CITY OF SUPERIOR
C. Reiss Dock
RFQ #23-17-PL

ADDENDUM #4

DATE: April 25, 2023

1 SECURITY FENCE
C2.01 - C2.04 NTS

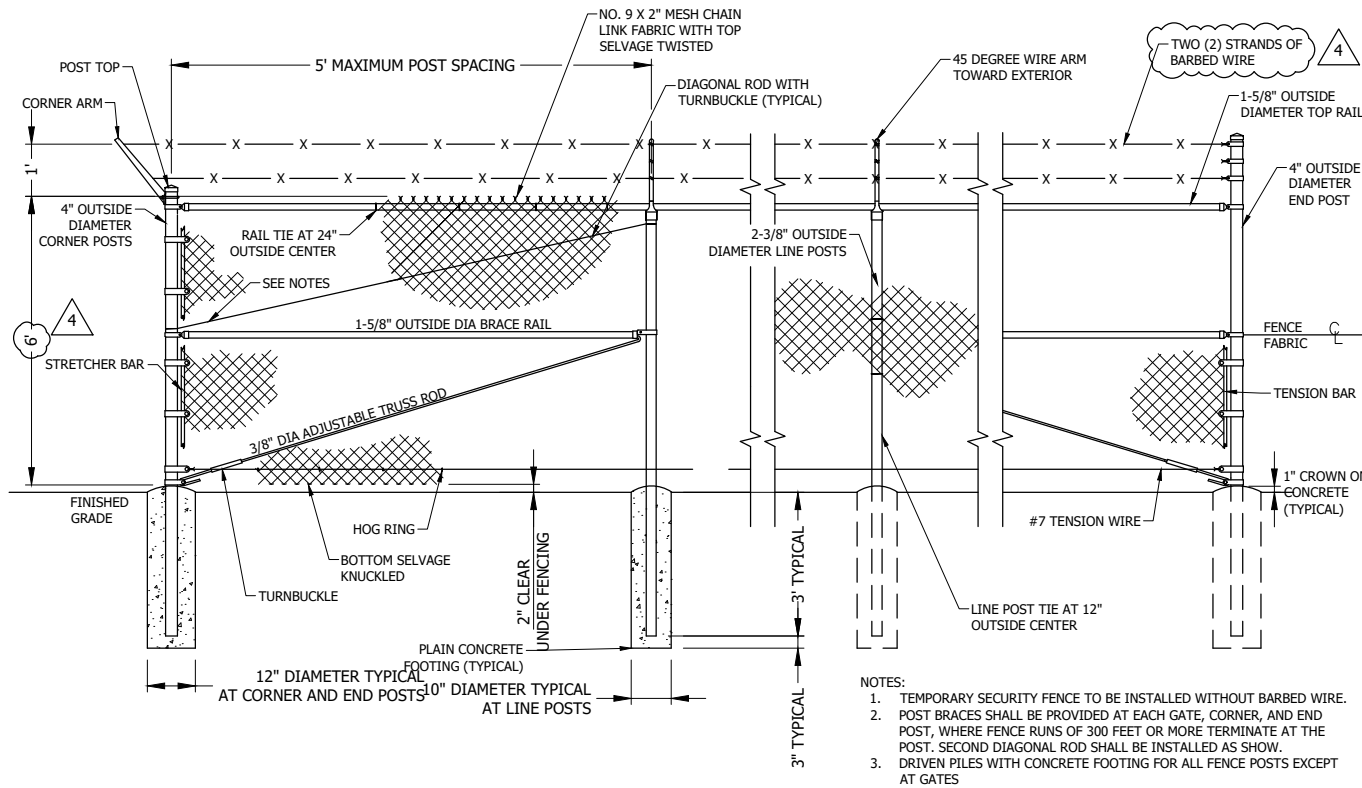
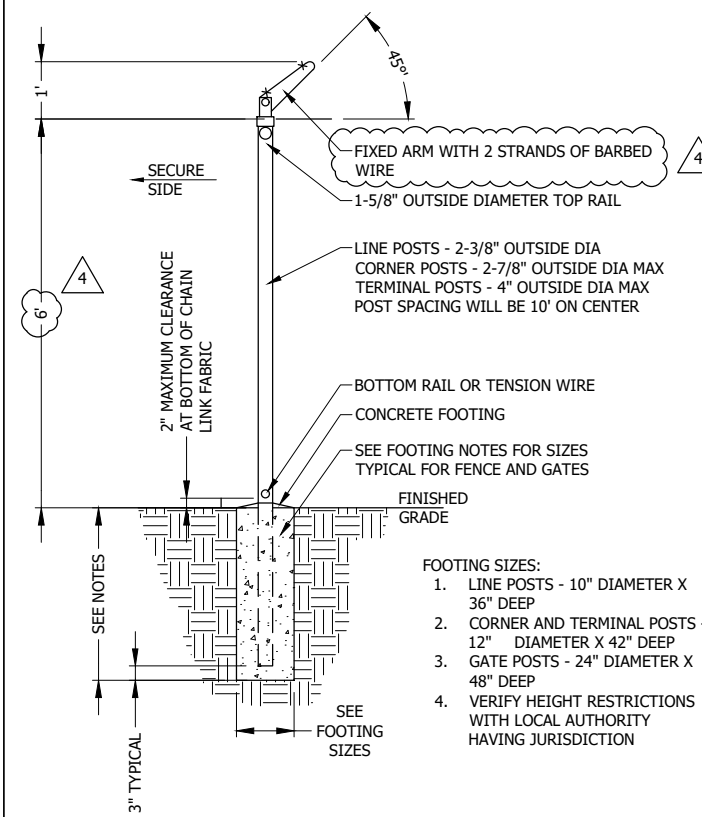
18. Q: The Fencing Spec section 32 31 13 does not comply with fence detail. Spec shows a 6' tall PVC coated. Detail does not mention PVC coated and shows 8' tall with barb.

19. Q: Fencing Detail 1/C8.04 has conflicting notes:

a. The detail shows posts 5' on center while fence note on same sheet mentions 10' on center (10' on center is typical).

b. The detail shows 4" terminal/corner post size while fence note on same sheet shows a 4" terminal post size but 2-7/8" corner post size (2-7/8" post size is typical for this height for both terminal and corner posts).

20. Q: Fencing Details show 36" deep footings for line posts, 42" for corner posts, & 48" for gate posts. Recommend changing to 12" X 72" footing for gate and corner posts and 6' drive set for line posts due to frost issues in area.

21. Q: Detail 1/C8.04 shows a 3/8" truss rod in combination with a diagonal rod with turnbuckle. Typical security fence only has a truss rod - to add a rod above the truss rod is redundant. Please clarify the if this is to be required.

A: Fencing Details on Sheet C8.04 have been revised accordingly. See attached.

A: Fencing Details on Sheet C8.04 have been revised. See attached.

A: Fencing Details on Sheet C8.04 have been revised. See attached.

A: Fencing Details on Sheet C8.04 have been revised. See attached.
